Service Bulletin

Subject: Whistle Noise Heard from Engine Compartment, Rough Idle and/or DTC P0171 Set

Models: 2011-2012 Chevrolet Cruze
Equipped with 1.4L Engine (RPO LUJ)

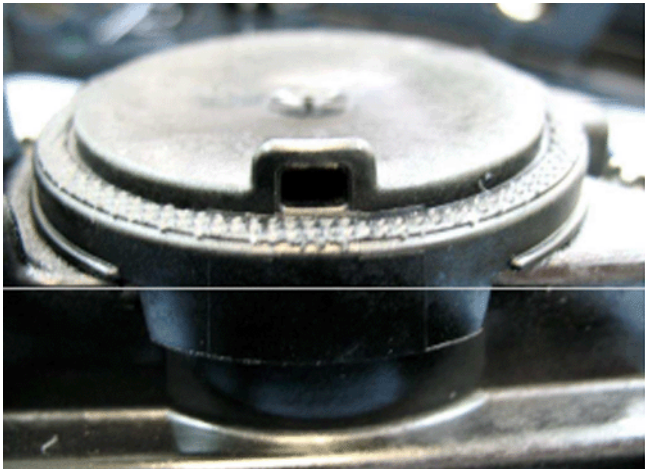
Some customers may comment on a whistle noise heard from the engine compartment and/or the vehicle runs rough with the service engine light on. This may be caused by a vacuum leak in the positive crankcase ventilation (PCV) located on the camshaft cover.

Note: The old style camshaft cover has a taller design PCV cap as shown in the illustration above.

Note: The new design camshaft cover has a flatter/lower cap as shown in the illustration above.

With the engine running using your finger, place it over the breather port of the PCV diaphragm to see if the whistle noise goes away and/or the fuel trims are

high then return to normal levels.

If the noise goes away, replace the camshaft cover and clear the DTC.
